SEDIMENT / DNAPL DELINEATION WORK PLAN

**DETREX RD/RA
SOURCE CONTROL AREA
DETREX FACILITY
ASHTABULA, OHIO
DOCKET NO. V-W-98-C-450**

**COMMENT RESPONSE TO REVIEW OF SEDIMENT / DNAPL DELINEATION WORK PLAN
DETREX RD/RA SOURCE CONTROL AREA / DETREX FACILITY
ASHTABULA, OHIO**

DRAWN BY: JSC	CHECKED BY: MS	PROJECT No: 13810732	DATE: 10/06/09	FIGURE No: 2A
------------------	-------------------	-------------------------	-------------------	------------------

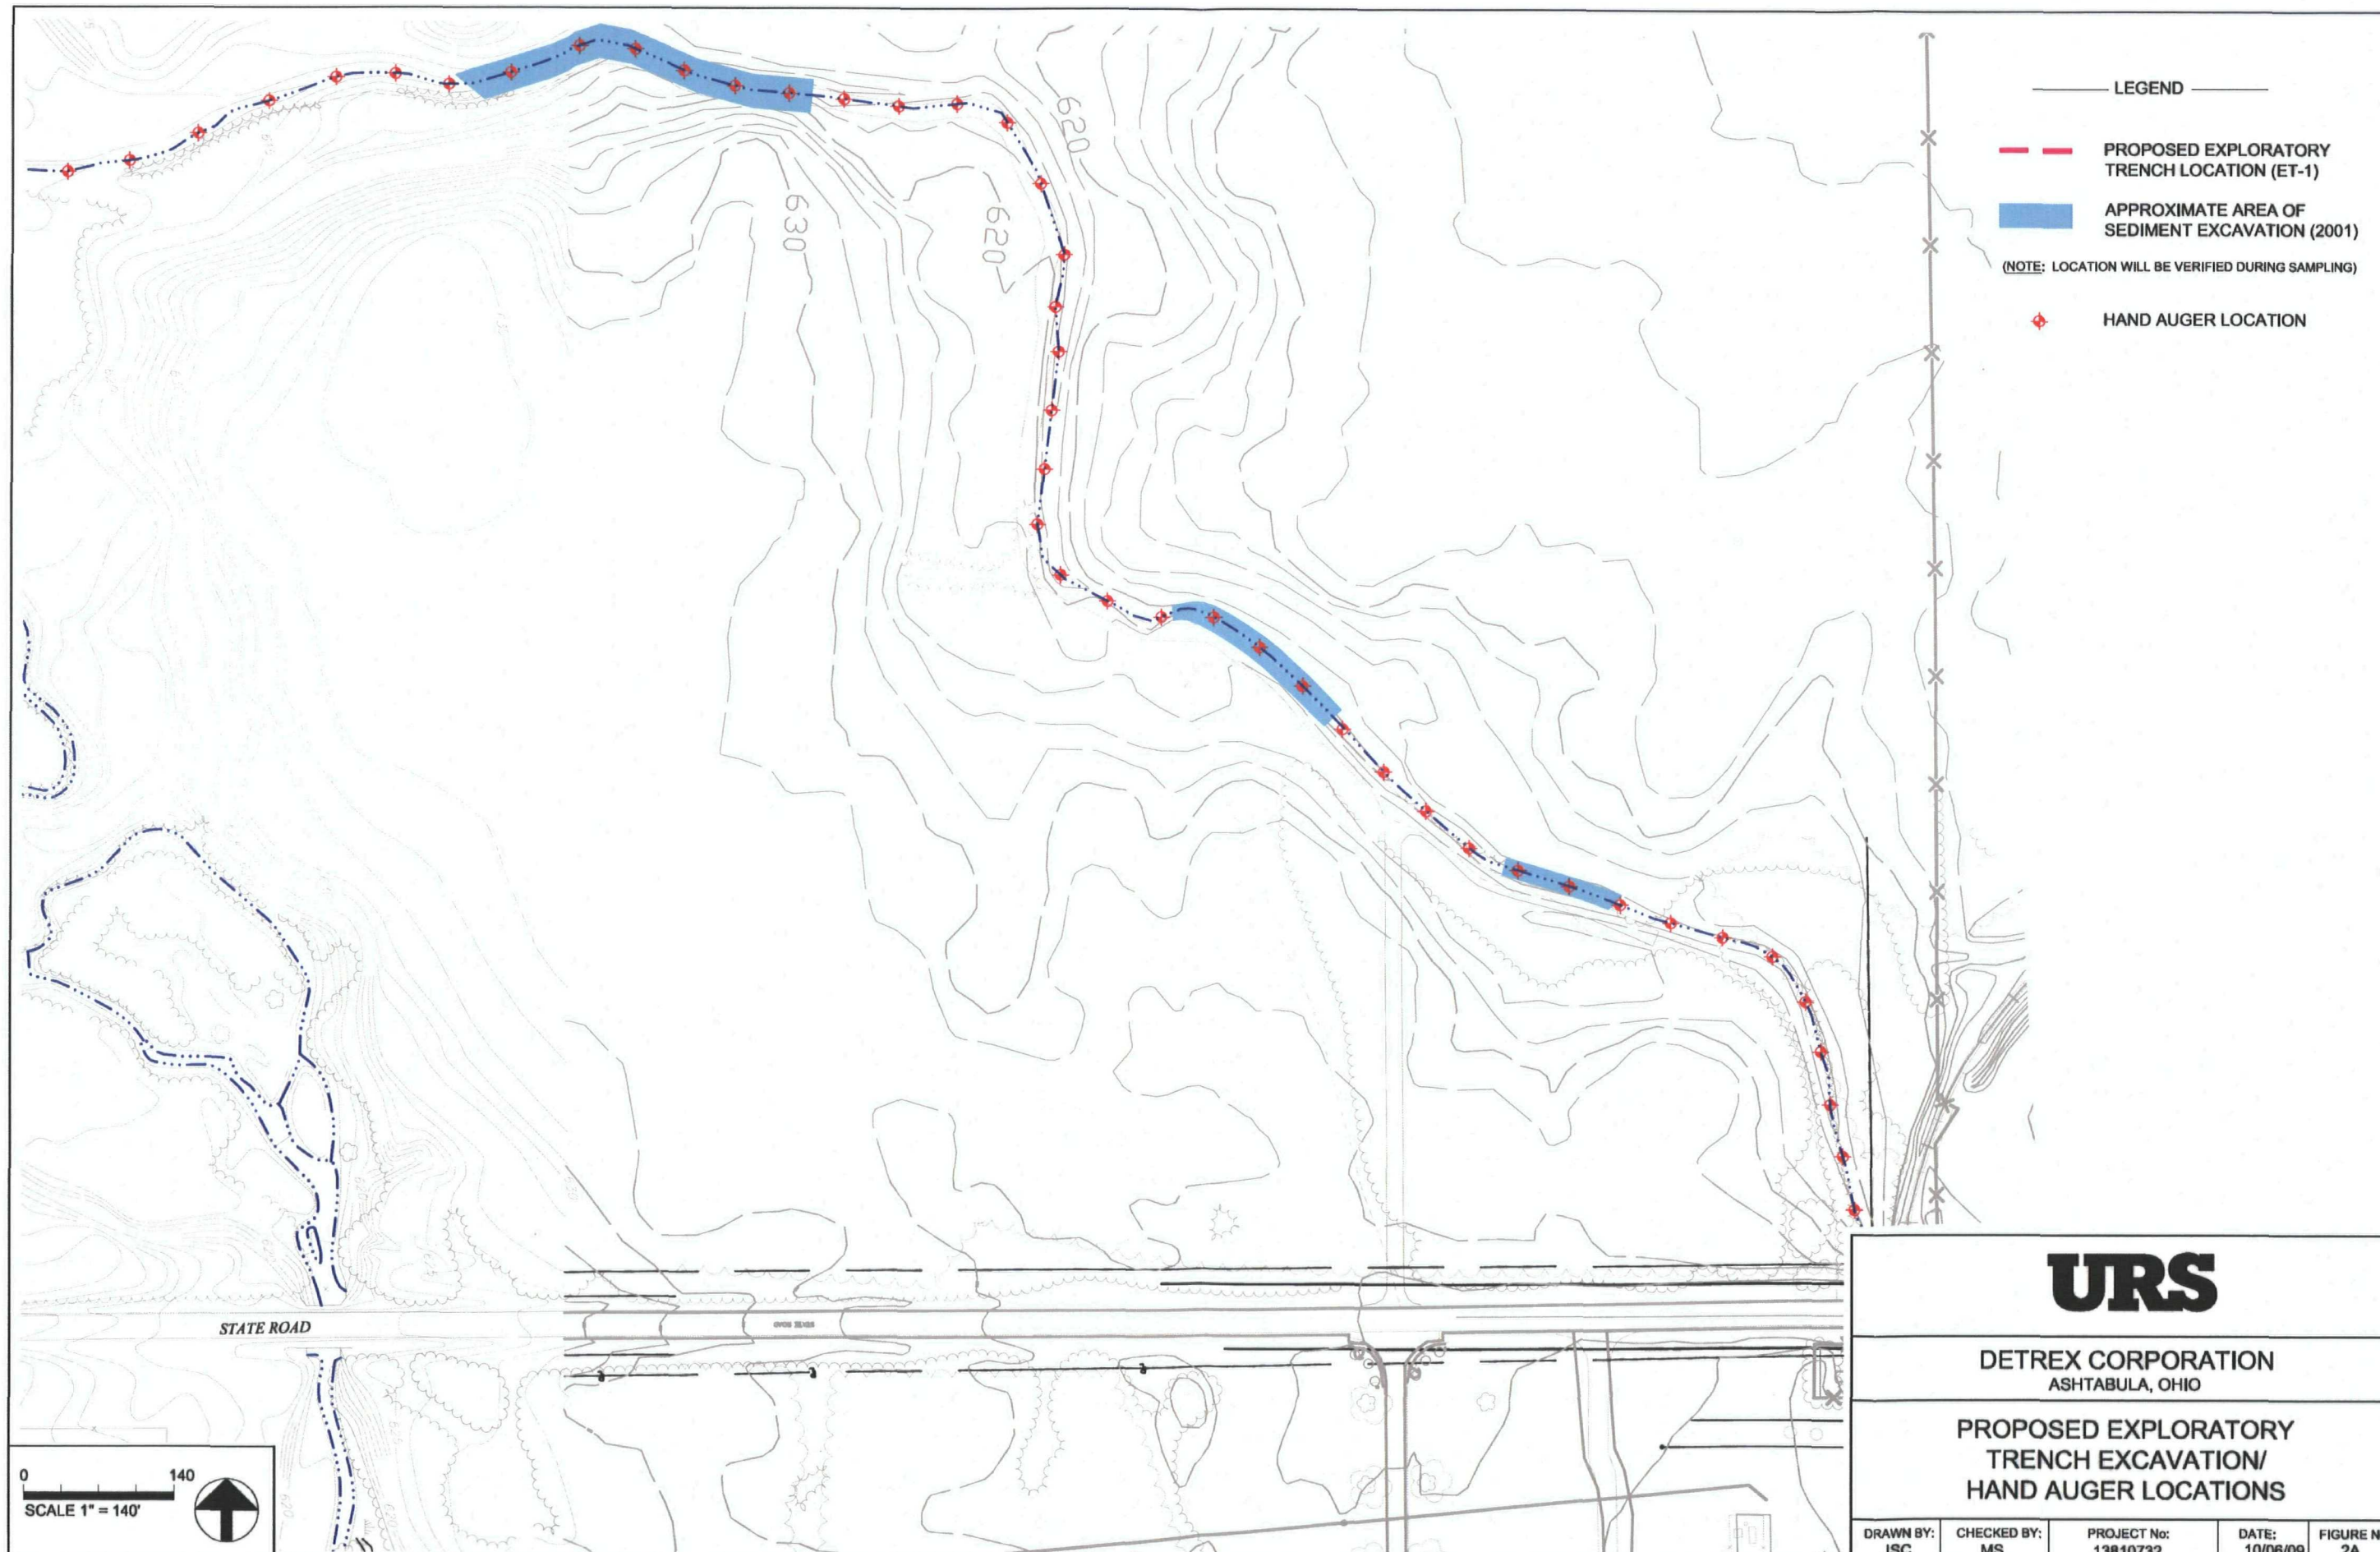
Section 3.2. Page 3.2. Based on the proposed approach, trench excavation and related field screening activities could potentially miss seams that contain DNAPL. SulTRAC recommends that field screening be performed on samples collected from all walls as well as the bottom of the exploratory trench and that the two samples from each trench with the highest readings be submitted for laboratory analysis.

In addition, the text proposes excavation of two trenches near State Road. The work plan should also specify that if the downstream trench shows evidence of DNAPL, additional trenches would be excavated until the approximate DNAPL extent is delineated. The work plan also should state that if DNAPL is observed or suspected in trenches at the intersection of the Fields Brook and DS Tributary, additional investigation would be performed upstream until the approximate DNAPL extent is delineated. The presence of State Road and the railroad spur are acknowledged as creating limitations on the ability to perform an investigation.

Detrex has revised the text to indicate that the sidewalls and bottom of the trenches will be screened and sampled accordingly.

In addition, the text has been revised discuss the results of sampling the trenches in the DS Tributary and Fields Brook. Results indicate nondetect in the DS Tributary and low VOC concentrations in Fields Brook. On October 22, 2009, USEPA indicated no further trenching was needed in the downstream portion of the DS Tributary.
